May 28, 2019

IDEA PUBLIC SCHOOLS  
IDEA EDINBURG CAMPUS PHASE III

## **ADDENDUM NO. 1**

## M.E.P SITE PLAN

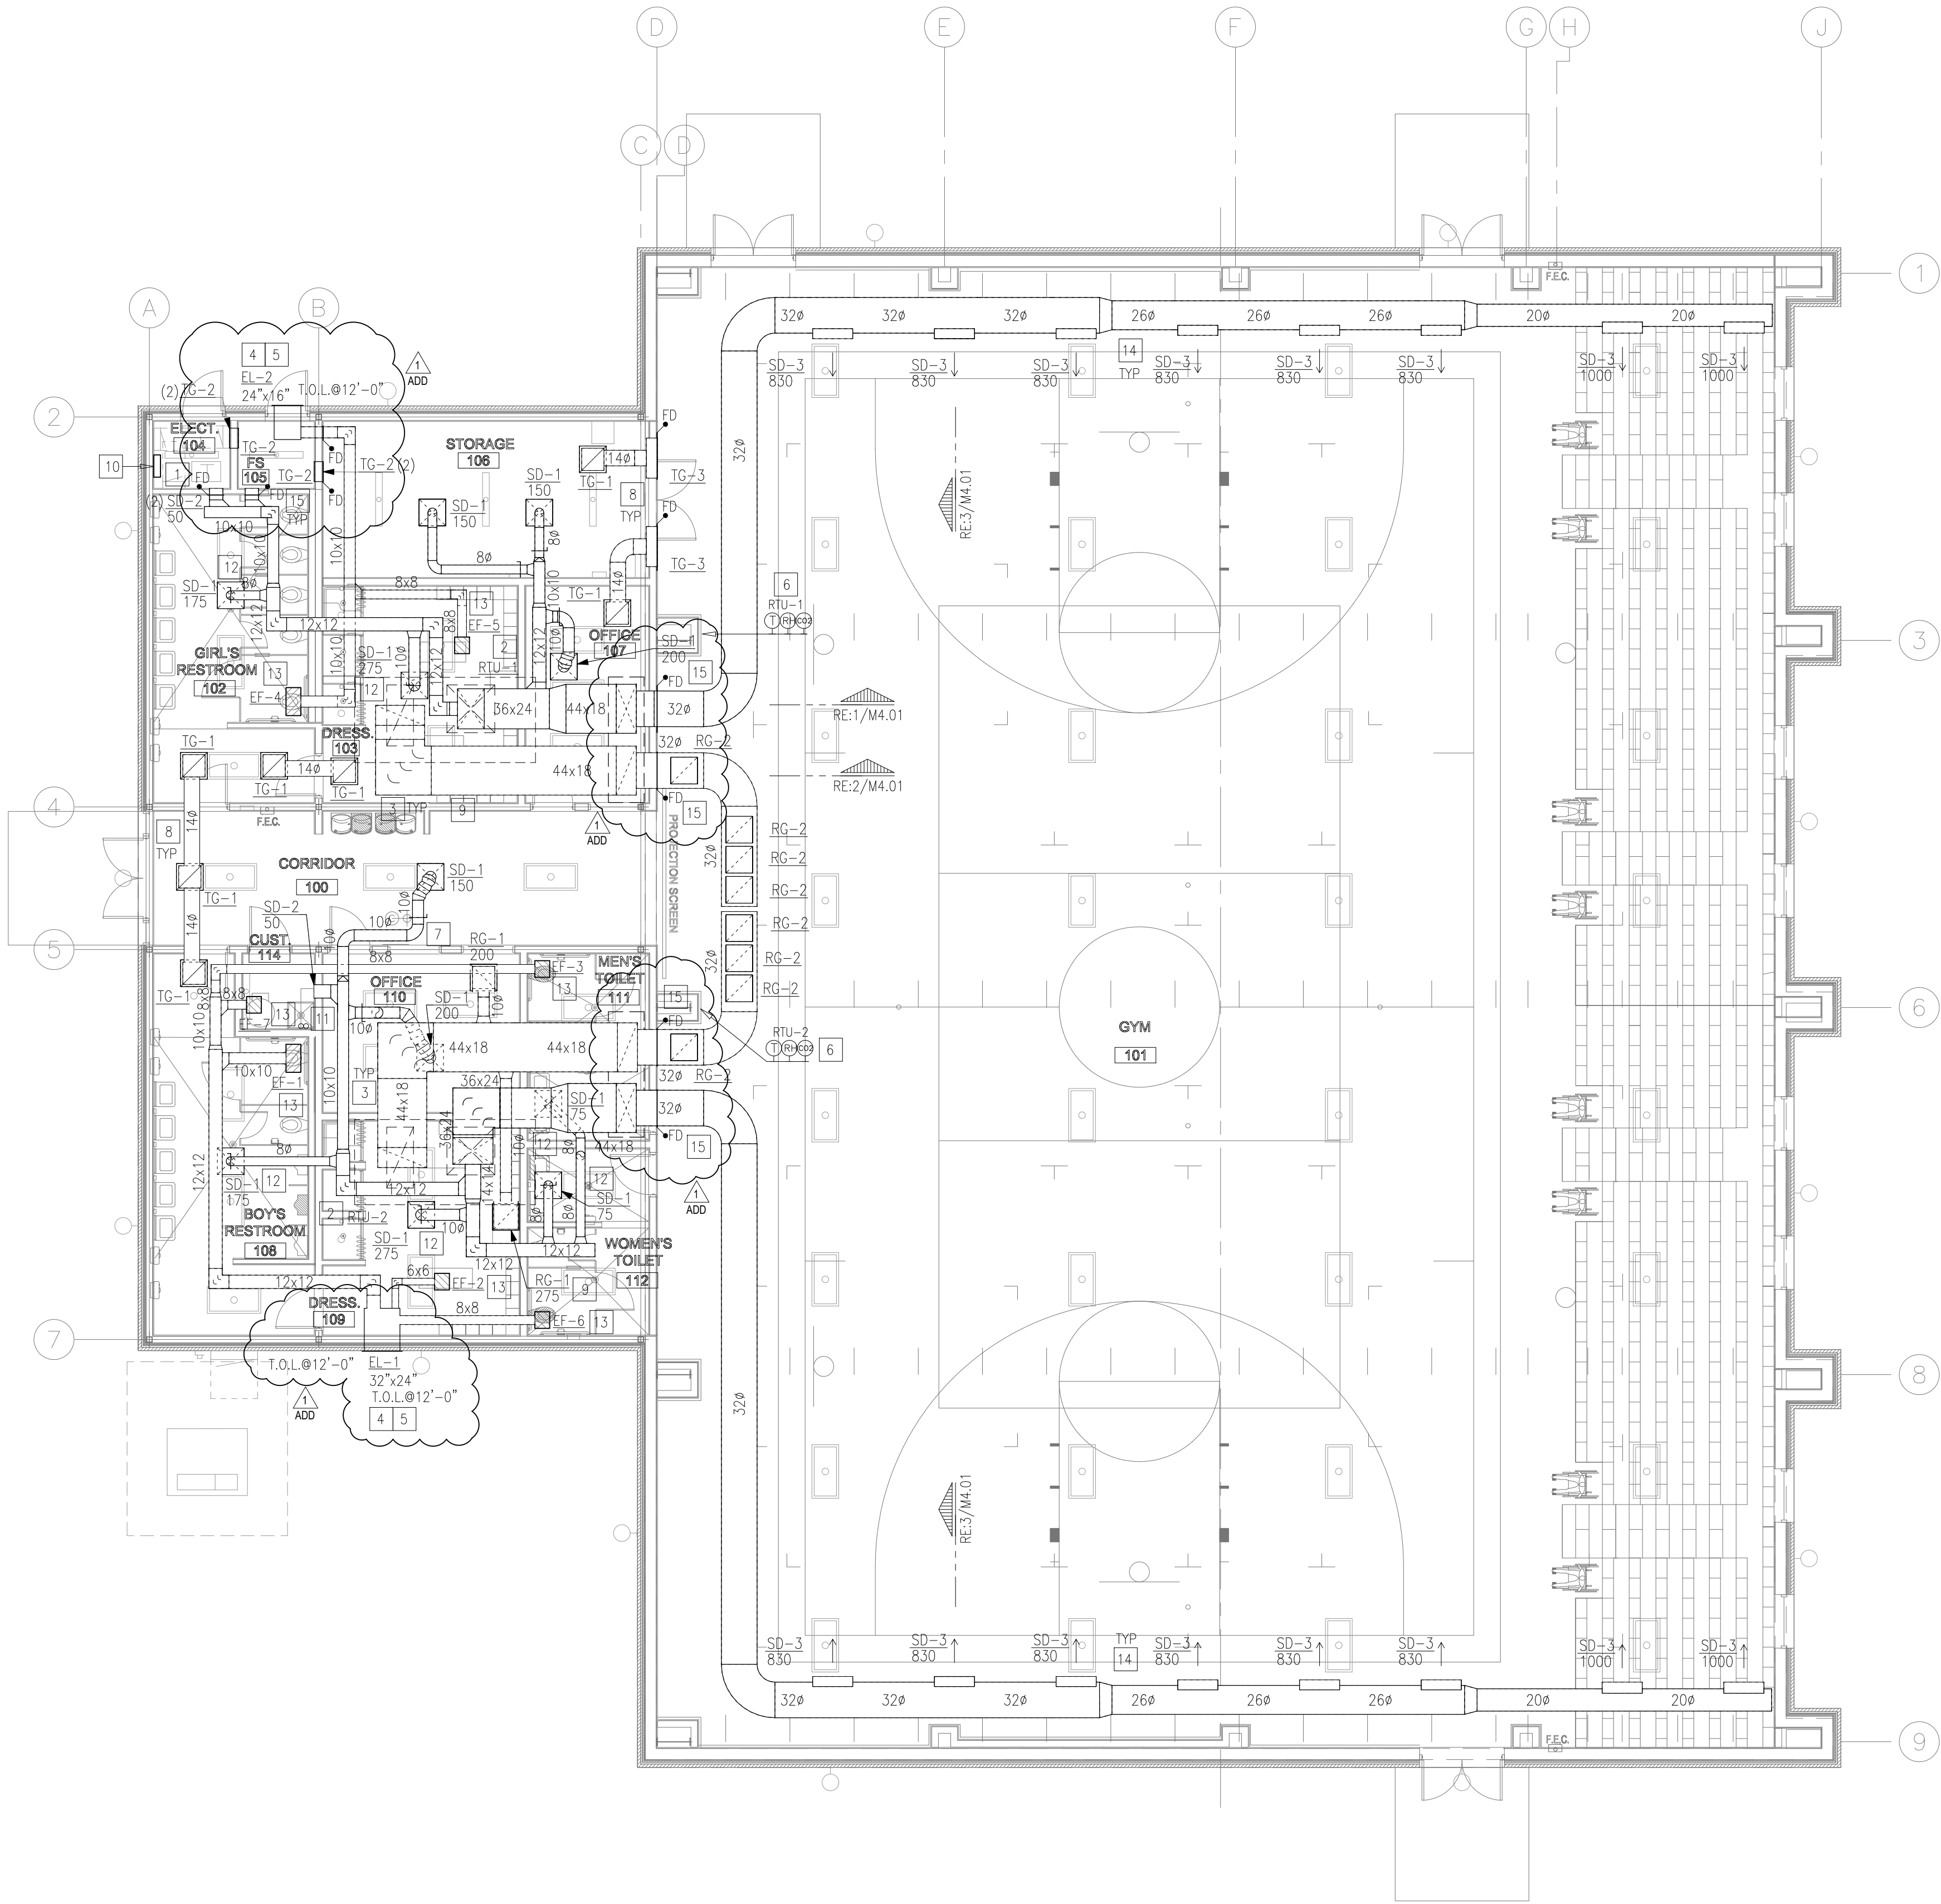
- 1) Sheet MEP1.01:
  - a) Revised MEP Site Plan. See attached sheet.
- 2) Sheet M3.01:
  - a) Revised Mechanical Plan. See attached sheet.
- 3) Sheet M4.01:

01 MECHANICAL ELEVATION  
SCALE: 1/4" = 1'- 0"

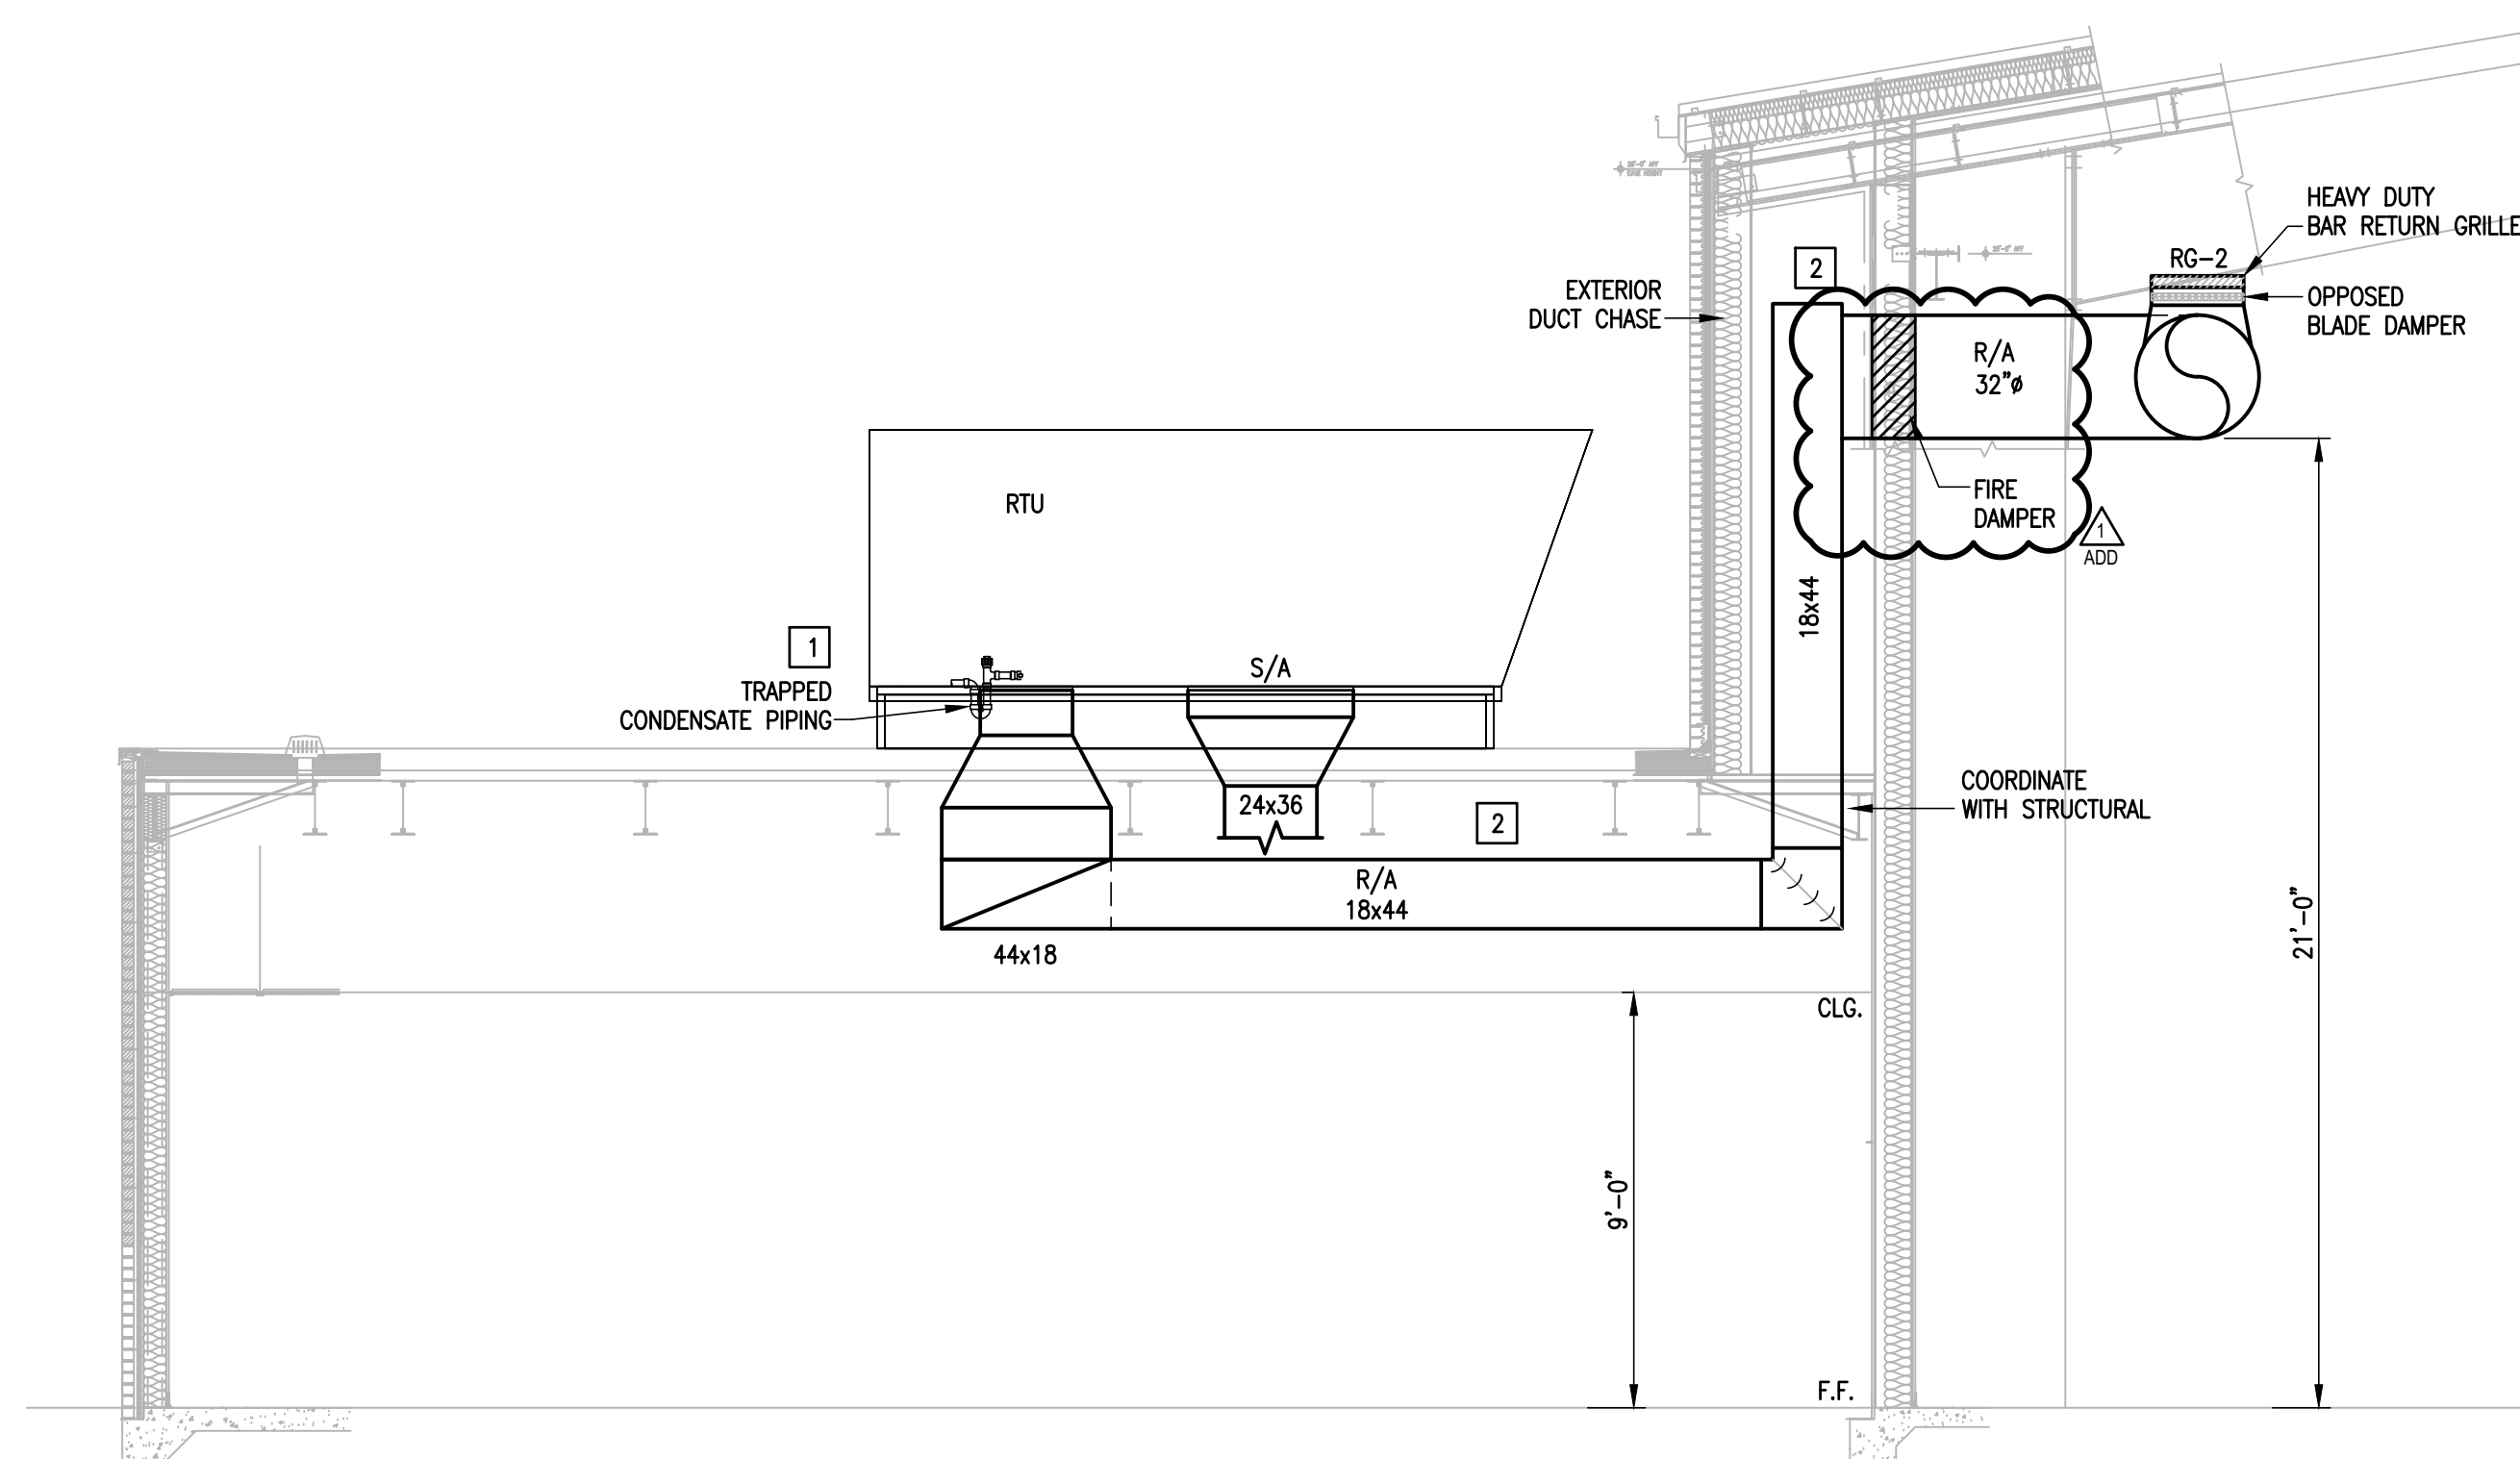
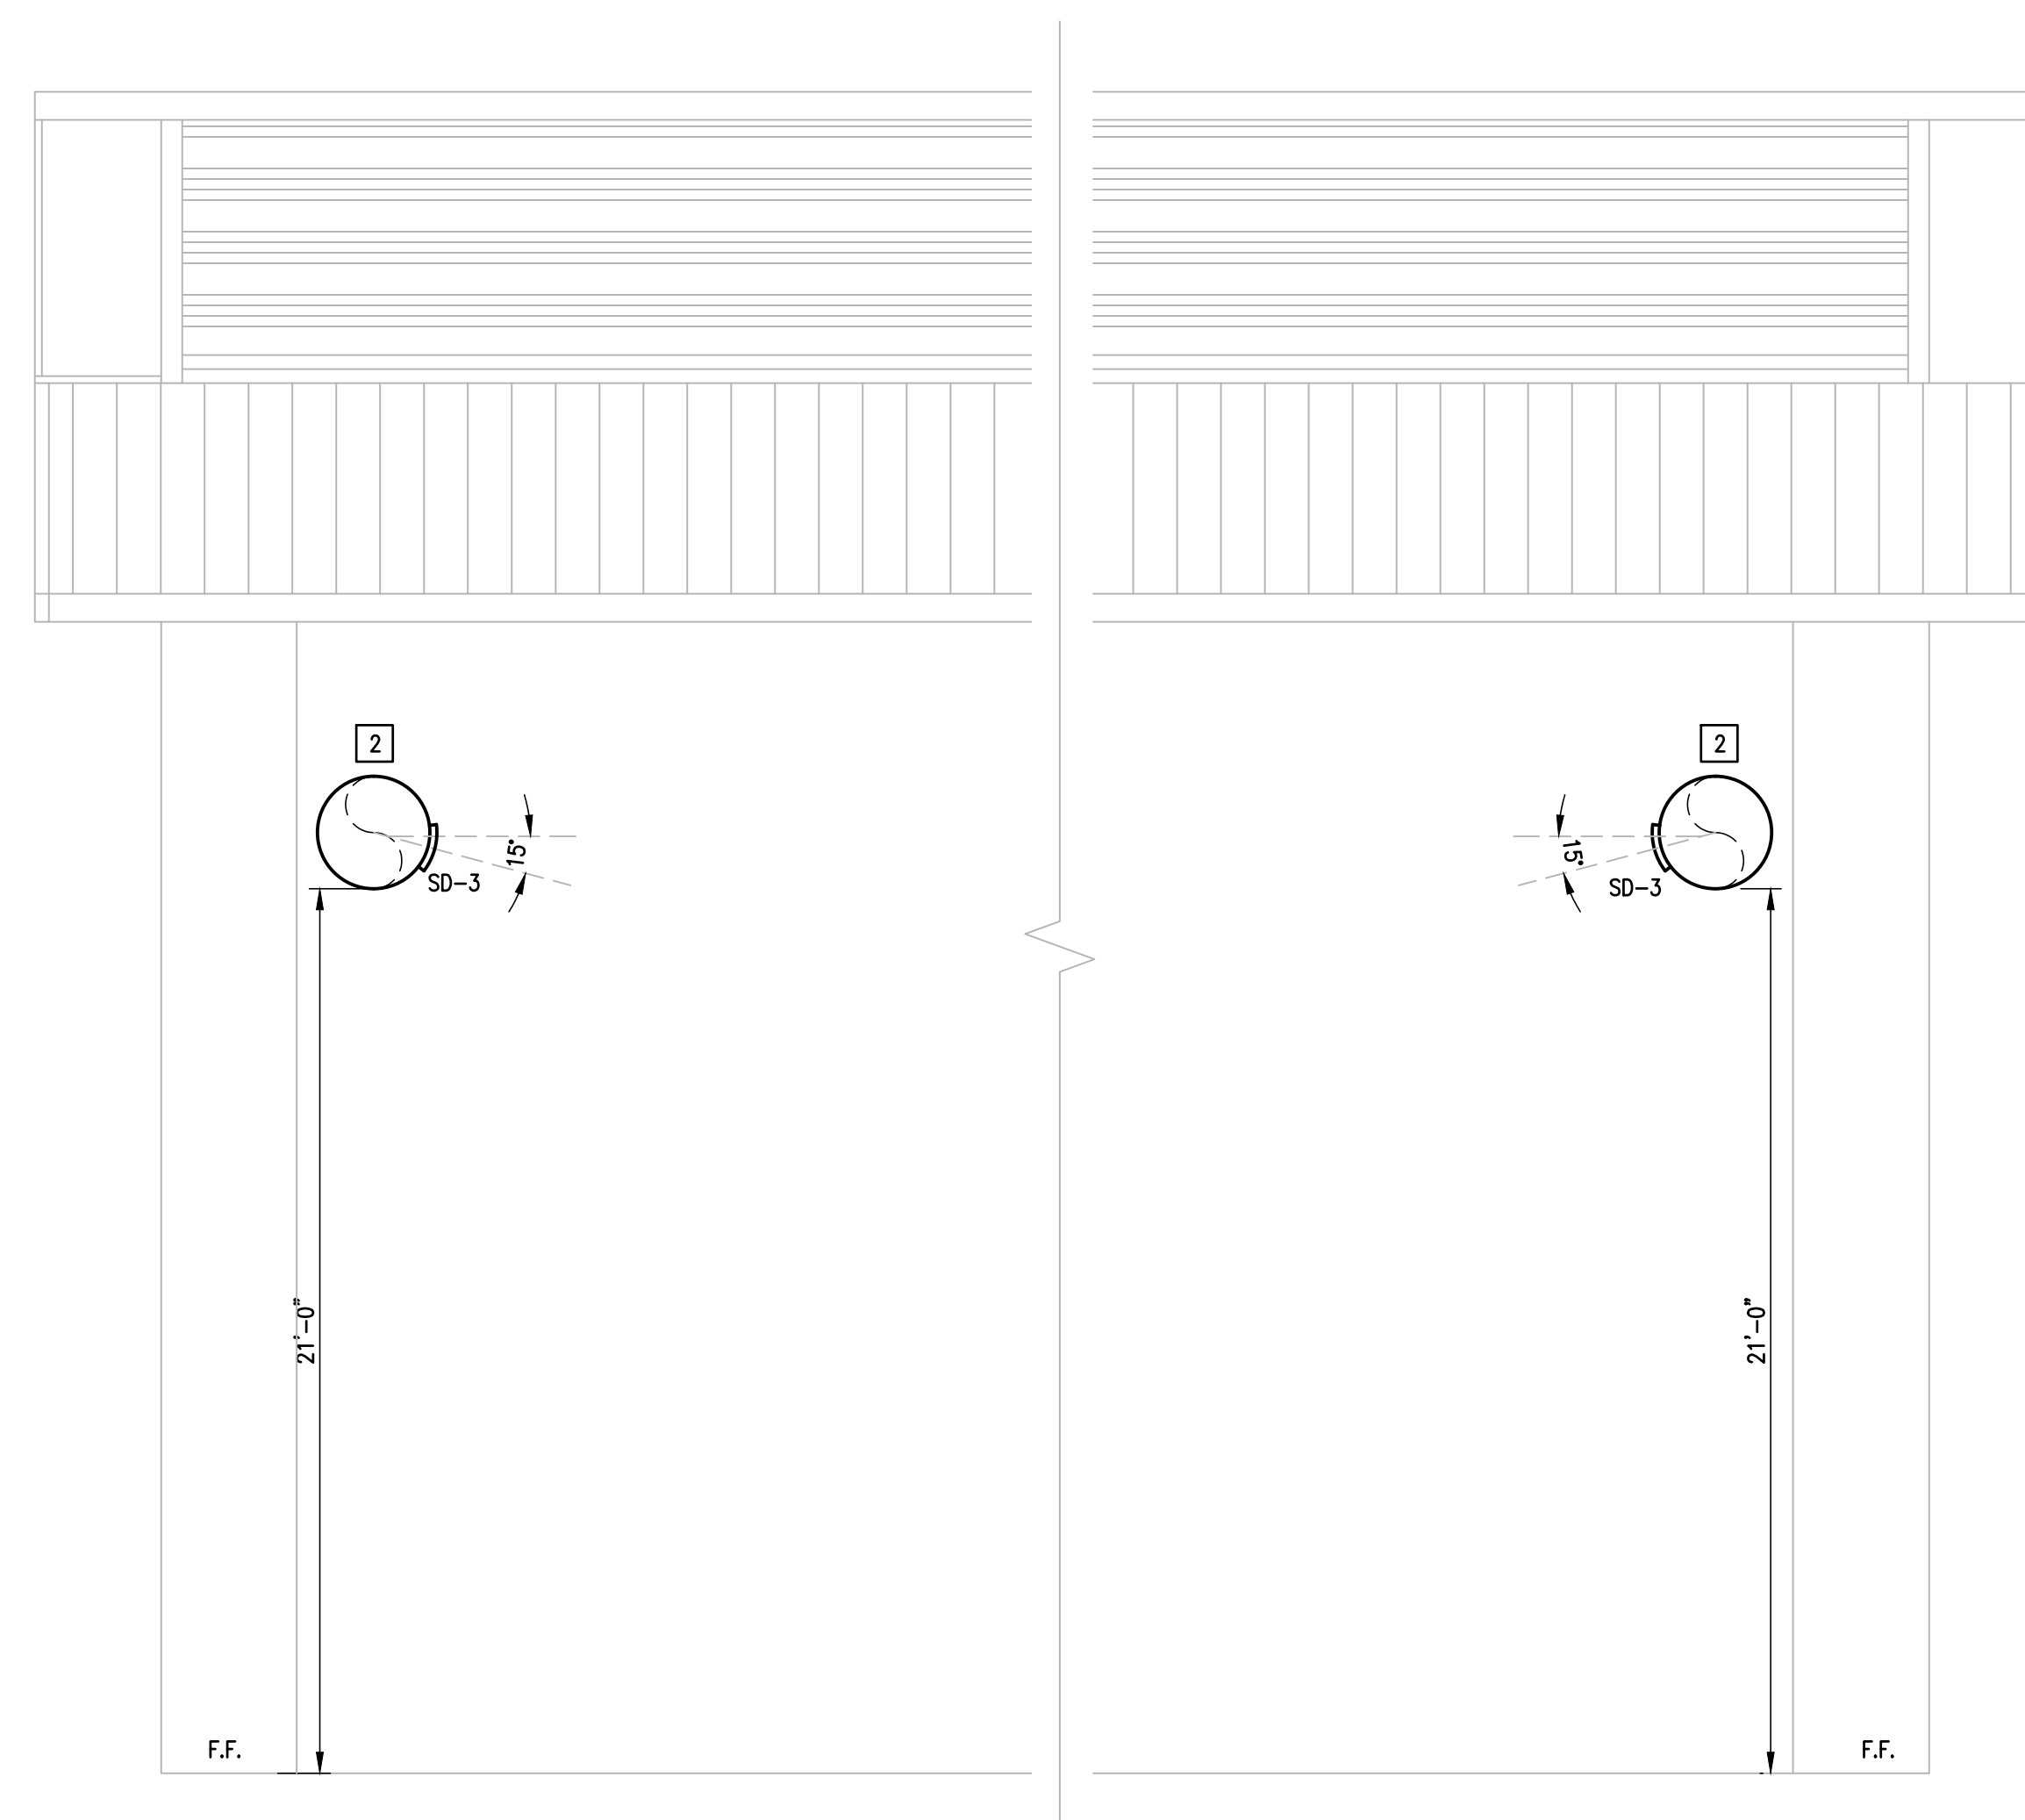
- a) Revised Mechanical Elevations. See attached sheet.
- 4) Sheet E2.01:
  - a) Revised Electrical Scope of Work and Symbols Legend. See attached sheet.
- 5) Sheet E3.01:
  - a) Revised Lighting Plan. See attached sheet.
- 6) Sheet E4.01:
  - a) Revised Luminaire Schedule. See attached sheet.
- 7) Sheet E5.01:
  - a) Revised Electrical Riser Diagram and Schedules. See attached sheet.
- 8) Sheet E6.01:
  - a) Revised and Added Electrical Details. See attached sheet.
- 9) Sheet P2.01:
  - a) Revised Plumbing Plan. See attached sheet.
- 10) Sheet P3.01:
  - a) Revised Waste & Vent Plan. See attached sheet.
- 11) Sheet P5.01:
  - a) Revised Plumbing Schedule. See attached sheet.
